APPENDIX C8

COMMENTS AND RESPONSES REPORT

DAISY SOLAR PHOTOVOLTAIC FACILITY, NORTHERN CAPE PROVINCE

(DFFE Ref. No.: 14/12/16/3/3/1/2763)

Figure 1: Vegetation type within the vicinity of the Kleinzee and Daisy PV Solar Developments

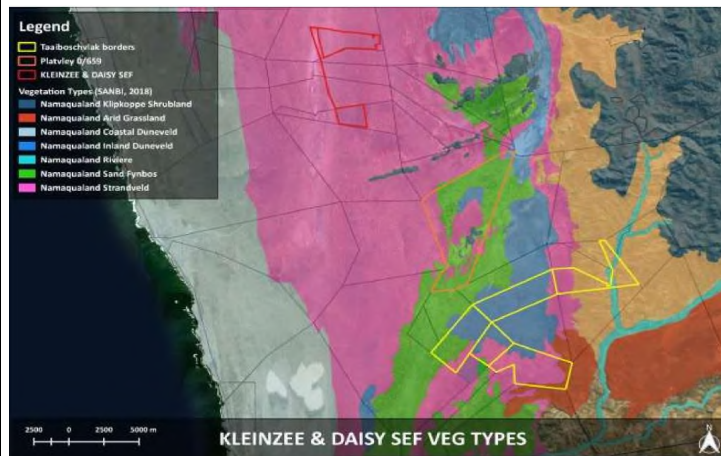
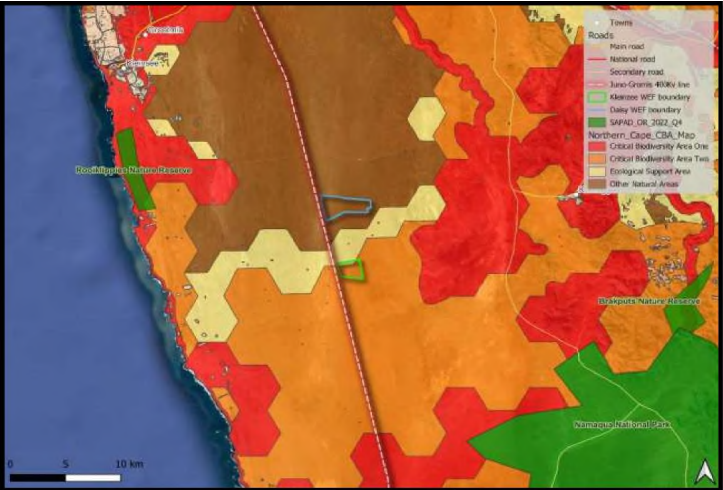
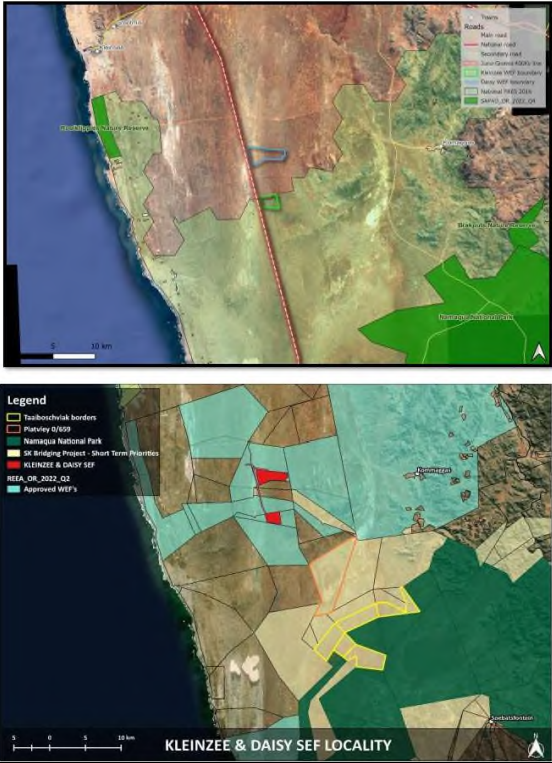
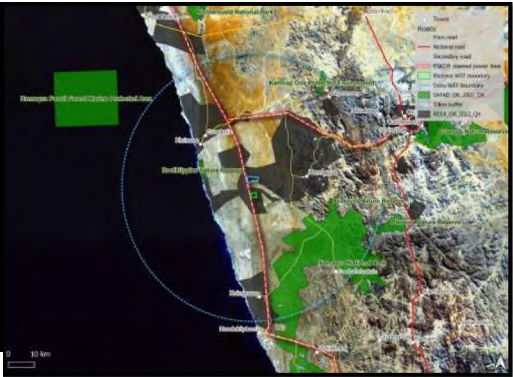
Vegetation units: The two proposed developments are located wholly within one vegetation unit, The Namaqualand Strandveld vegetation unit (RSA vegetation map 2018). It has a conservation target of 26% although the COP 15 agreement of parties targets 30% of ecosystems by 2030 at the broader scale. The vegetation unit is classified as poorly protected in the 2018 NBA (5 – 50% of the conservation target achieved). The vegetation unit is not classified as a threatened ecosystem.

impacted to a relatively limited extent by transformation to date and is classified as Least Threatened.

Figure 7: Renewable Energy applications in the region according to the DFFE Renewable Energy database (REAA_OR_2022_Q4)

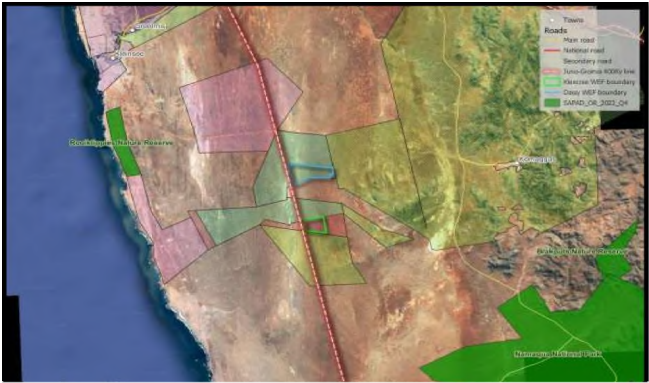
| <p>Figure6: (a) Renewable energy applications within 50km from the proposed Daisy and Kleinzee PV facilities and (b) extent of the Phase 1 Renewable Energy Development Zone</p> <p>Various wind farm projects have been proposed and submitted to DFFE for environmental authorisation to date in the vicinity of the proposed Daisy and Kleinzee PV facilities. (Figure 7). Some land parcels shown are much larger than the actual footprint of the proposed development (e.g. Kap Vley WEF which only constitutes a small portion of the Kommagas commonage land), whereas others covers the majority of the land parcels (Figure 8).</p> <p>The exact footprint of the proposed Kleinzee and Daisy PV facilities are unknown, with the BAR indicating that all of the two projects' land parcels are development area, except for some excluded dunes in the Daisy land parcel based on recommendations from the ecological specialist. The ecological specialist indicated during the site visit that only the western flat terrain of the Daisy land parcel is of interest for development. The proposed Kleinzee and Daisy PV facilities are the only non-wind applications to date in this area. They are located on the same land parcels as other existing renewable energy applications (i.e. Daisy PV is located on the Zonnequa WEF site and Kleinzee PV is located on the Namas WEF site).</p> | | |

Figure8: Renewable energy applications refined, showing wind farm turbine footprints for proposed projects (electricity grid infrastructure not shown).The footprint for the proposed ESKOM 300MW wind farm south and east of Rooiklippies Nature Reserve is not indicated.

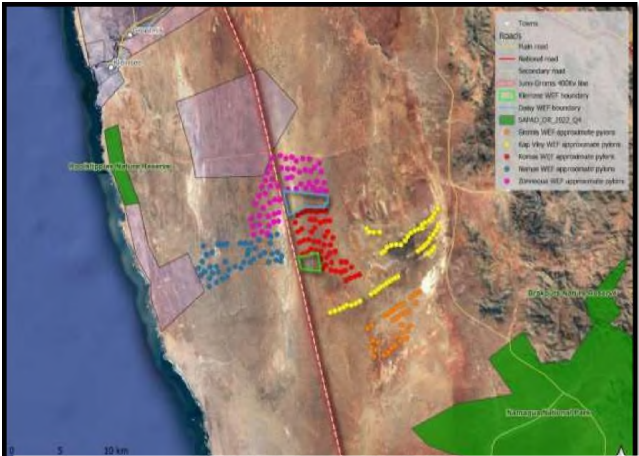
| | <p>The status of the array of renewable energy applications in the region is unknown, with uncertainty over whether projects will go ahead, although all projects have received environmental authorisation. It is, therefore difficult to make assumptions and recommendations on potential cumulative and landscape-level impacts.</p> | | |

Figure 10: Coastal vegetation units near the proposed Daisy and Kleinzee PV facilities (RSA vegetation map 2018).

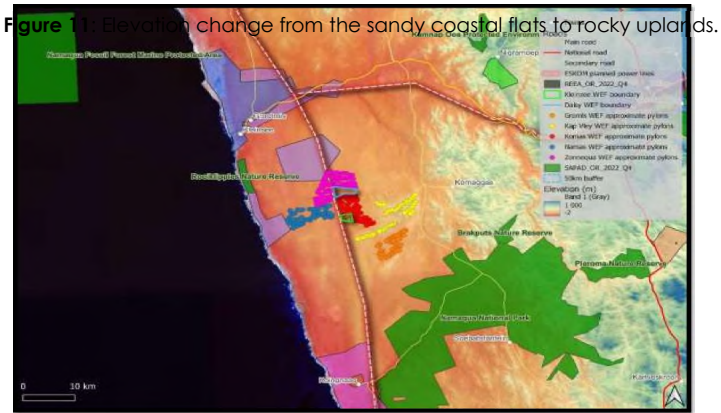
| | <p>The sandy coastal habitats and vegetation structure that occur between Kleinsee and Kommagas towns (Figure 10 and Figure 11) are derived from specific environmental conditions that include a combination of low total annual rainfall, winter-dominated rainfall (Mediterranean climate), rainfall variability, high evapotranspiration and water balance deficit levels, a sharp moisture and temperature gradient from near the coast (cool temperatures, regular mist) to the inland (increasing temperature, reducing mist frequency), prevailing wind direction (south to south-westerly) as well as changes in sandy substrate character, topography and mobility. The broad-scale delineation of vegetation types in the National Vegetation Map does not capture all such environmental and habitat nuances.</p> <p>If all proposed renewable energy developments are to materialise as indicated, there is a high likelihood that some degree of landscape-level disturbance and barrier creation could manifest from cumulative impacts. These impacts could manifest in both the north-south axis and the east-west axis around the area in question along various environmental gradients and ecological processes. If most of the proposed developments do not materialise and the proposed Kleinsee and Daisy PV facilities are seen in isolation, then landscape-level impacts would be low. It is worth considering that both the proposed Komas/Gromis and Kap Vley wind energy facilities had triggered biodiversity offset investigations in their own specific contexts. Mitigation measures for proposed projects are normally restricted to the direct environmental impacts on the sites of those activities, such as the placement of infrastructure to avoid sensitive habitats and specific operational rules. It would however be difficult to have on site mitigation strategies that can compensate for landscape level disturbances. The challenge here</p> | | <p>In order to address concerns about the potential impact of the Kleinsee PV Cluster on the future potential of the Namakwa National Park to expand into this area as well as general cumulative impacts likely to be associated with the current PV developments and already authorized wind energy facilities present in the immediate area, a biodiversity offset analysis report was drafted and included as Appendix P to the BA report. The findings of this report indicate that that an offset for the Kleinsee PV Cluster is not considered necessary or appropriate when the facilities are considered each on their own or when considered together for cumulative impact.</p> <p>The specialist has clarified that there is a distinction between the nature of impacts associated with wind energy developments and solar energy developments. The footprint of wind energy facilities is dispersed across the landscape and there are additional edge effects particularly for fauna associated with turbine noise and other associated types of disturbance. Solar energy development has a more intense, localised disturbance and significantly impacts biodiversity within the development footprint, but edge effects can be reduced to a low level. As such, the footprint of PV facilities is more clearly defined and locally concentrated and provided that the location of the PV footprint is suitably chosen, then impacts tend to be relatively low when assessed at the landscape level.</p> |

Figure 1

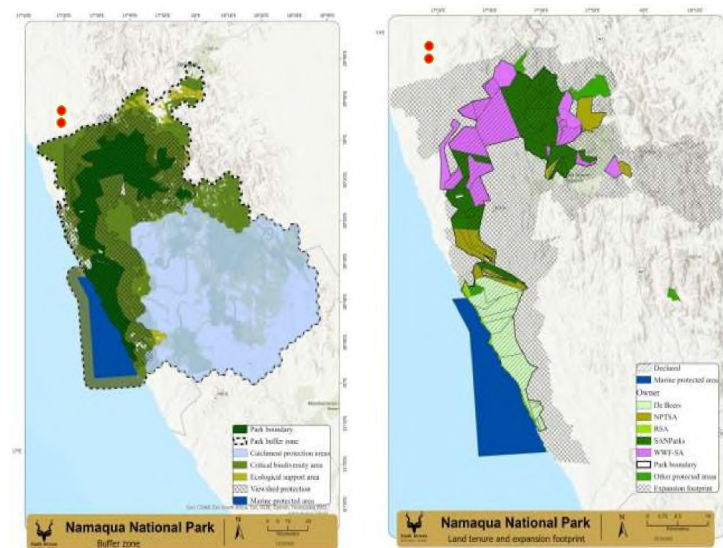
developments lie within a renewable energy development zone. However, importantly, it is noted that the renewable energy zones were developed before the SANParks' Land Inclusion plan was adopted by the Minister of Forestry, Fisheries and the Environment (Minister). A portion of the proposed developments (see **Figure 1** below) falls within the expansion footprint of the Namaqua National Park. The proposed developments also fall within the current buffer zone of the Park.

By pursuing development within a recognised priority area for conservation (taking into account the multiple values of the affected area as a national protected area expansion strategy focus area, a CBA 2, the buffer zone of the Namaqua National Park and within the expansion footprint of that Park), the proposed

It should be noted that the proposed projects are located in a gazetted Renewable Energy Development Zone, i.e., in an area that Government has determined to be suitable for PV facility and Wind facility developments.

According to **Appendix D** of the BA report, the Daisy PV Facility lies within an area that is considered relatively low sensitivity on account of the homogenous nature of the vegetation and the low abundance of plant SCC.

In addition to the Terrestrial Ecology Assessment, a Biodiversity Offset Analysis report has been undertaken to determine the biodiversity importance of the area in assessing the impact significance of the proposed PV projects. The Biodiversity Offset Analysis report is attached as **Appendix P**. the findings of this report indicate that an
